Arcos Executive Center

Village Council

May 9th, 2018

COMMENTS FROM COUNCIL 1ST HEARING

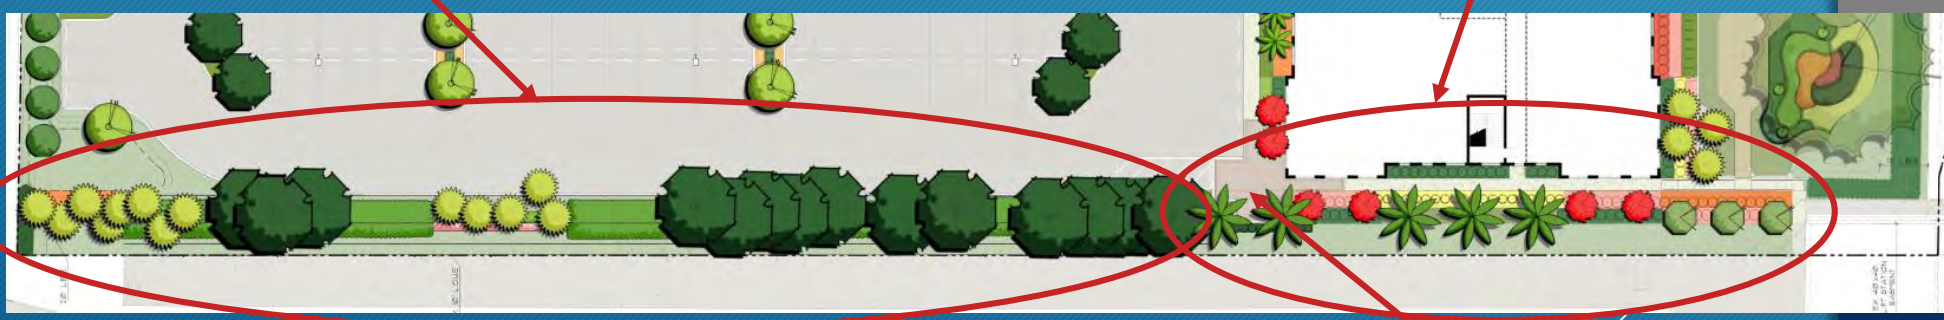
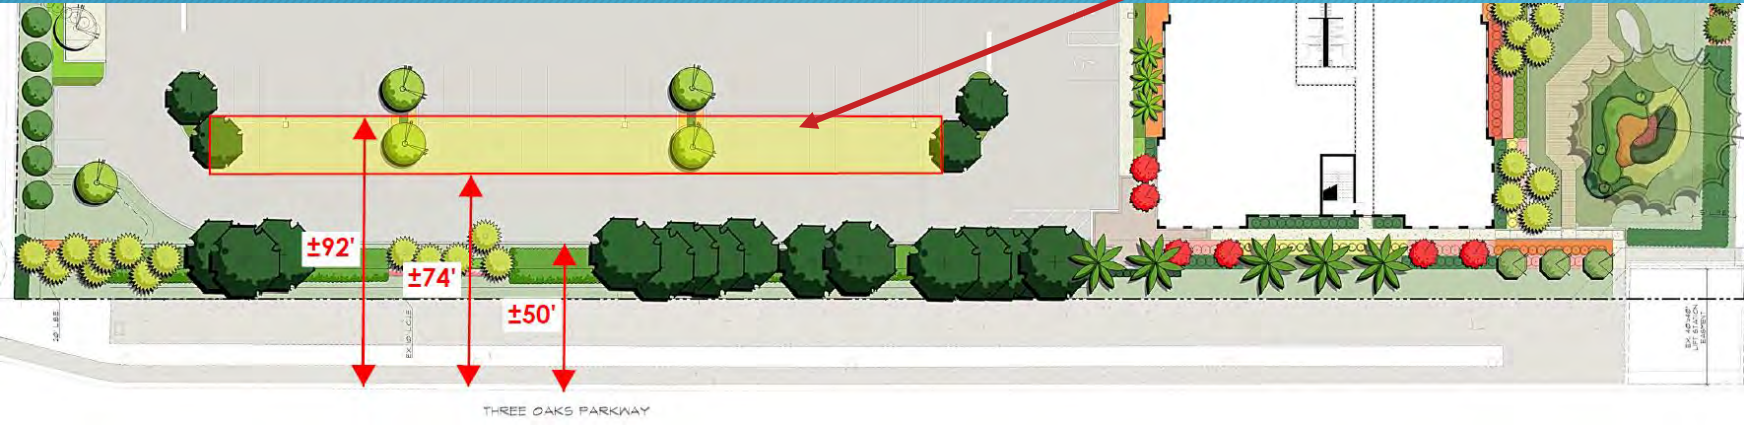
1. Will the Landscape Buffer along Three Oaks Parkway be opaque enough to block the vehicle headlights from the Arcos Executive Center parking lot?

- FIRST PLEASE NOTE THE FOLLOWING BUFFER CHANGES:

OLD PLAN (BRAND NEW BUFFER)

UTILIZE EXISTING
BUFFER PLANTINGS

PROPOSE NEW
MATERIAL FOR BUFFER

PROPOSED PLAN (HYBRID BUFFER)

Distance to Three Oaks:

- ±50' from the parking lot back of curb
- ±74' from the first row of parking
- ±92' from the second row of parking

Vehicle headlights will face away from Three Oaks Parkway in this row of parking spaces.

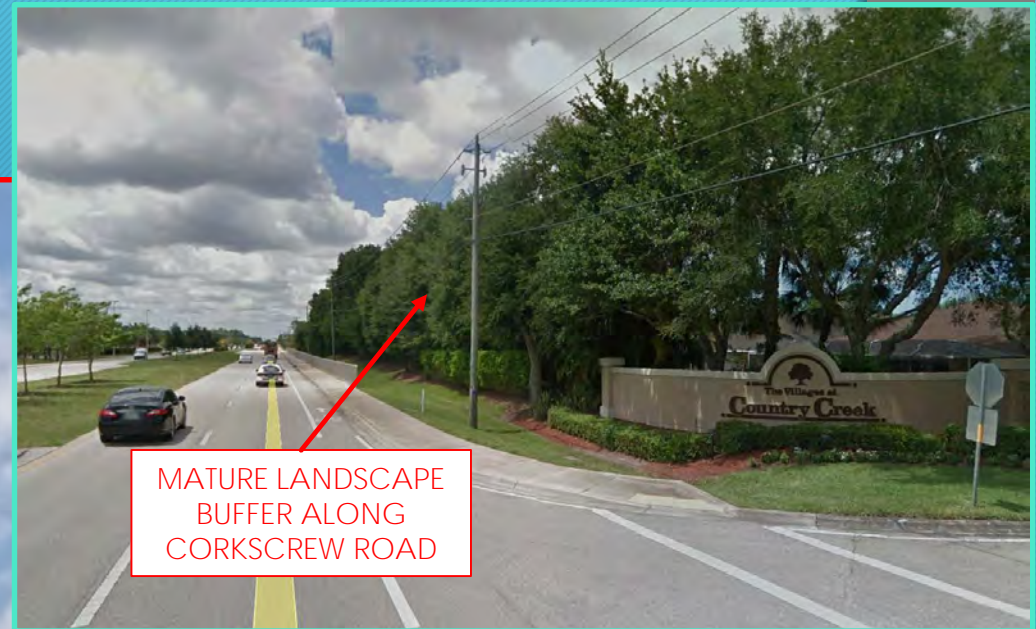
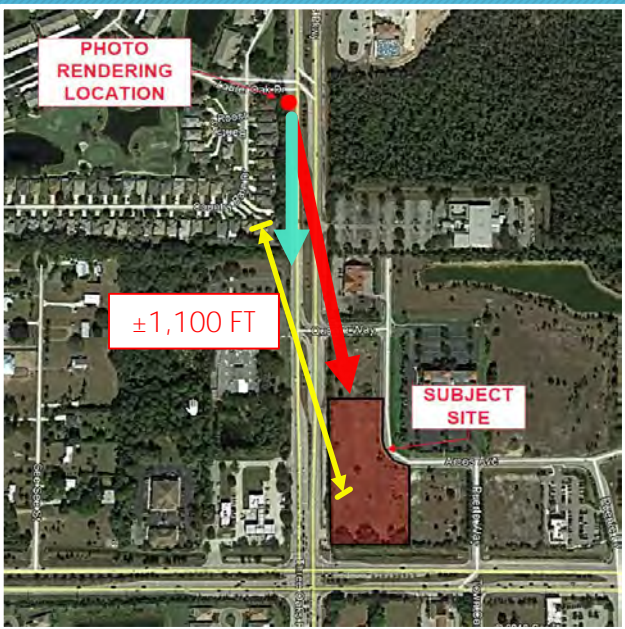
6. What is Existing, Approved, and Proposed in the Plaza Del Sol Subdivision?

- UNDEVELOPED
- EXISTING
- PROPOSED

The Villages at Country Creek Community Entrance

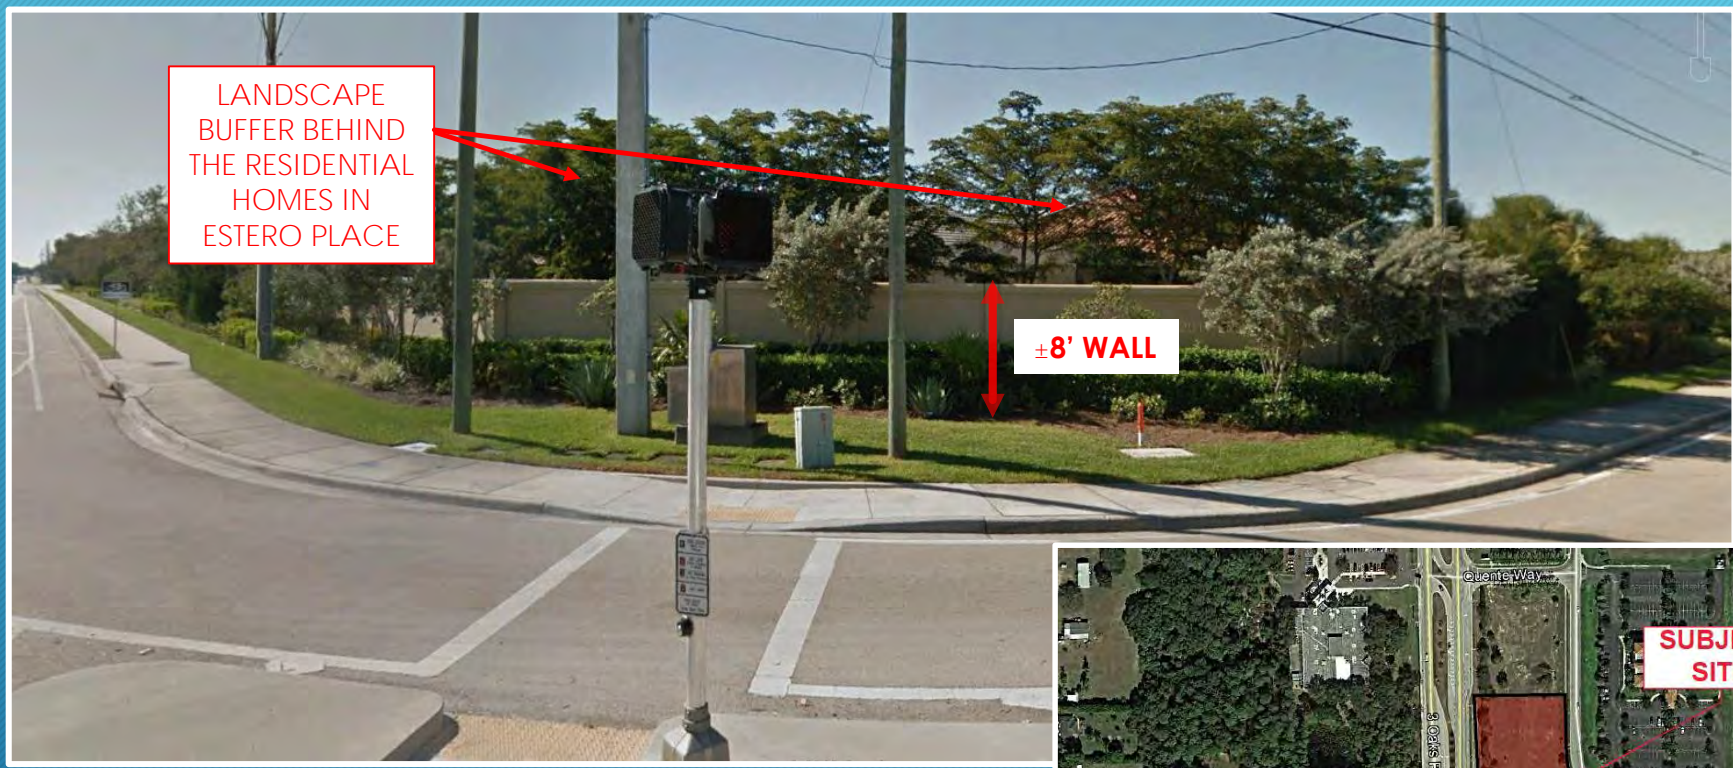
7. Please provide a Line of Site Diagrams for neighboring residential communities.

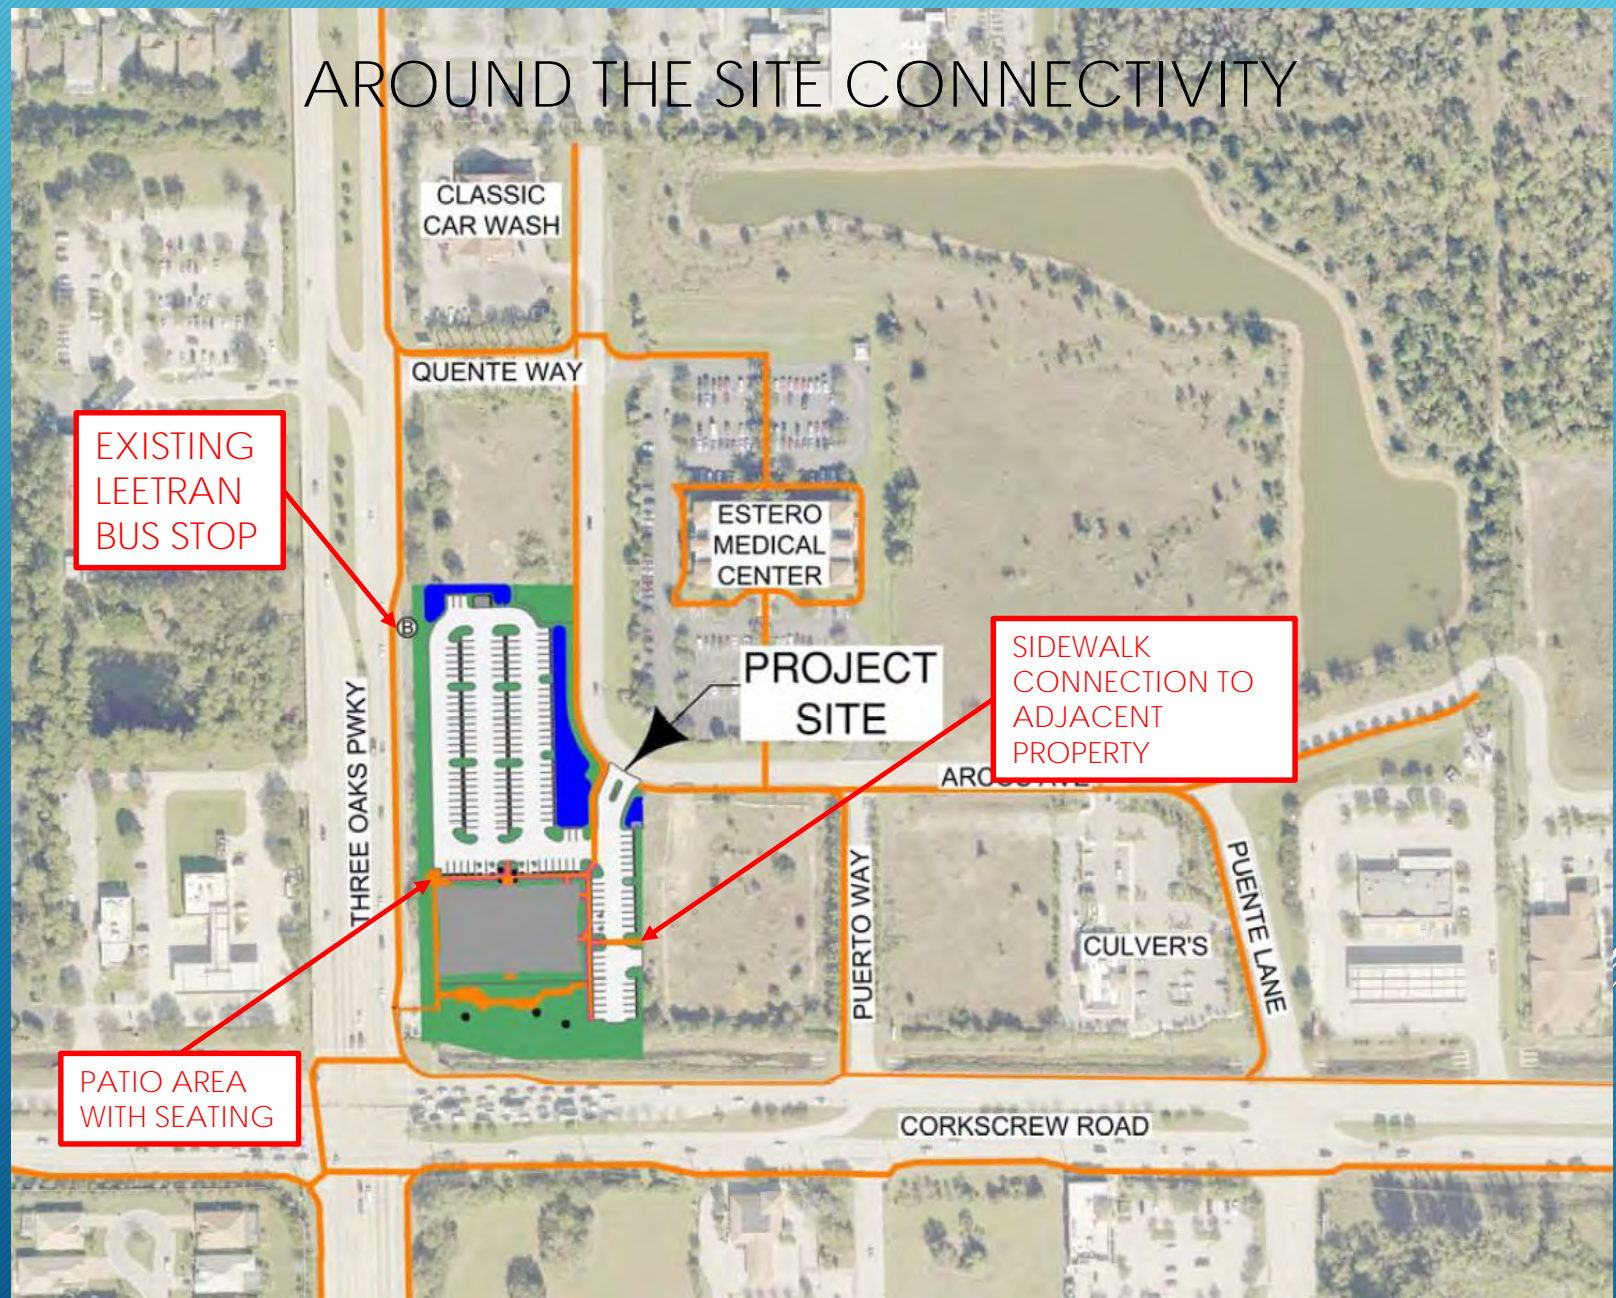
10. What is the pedestrian connectivity in and around the site?
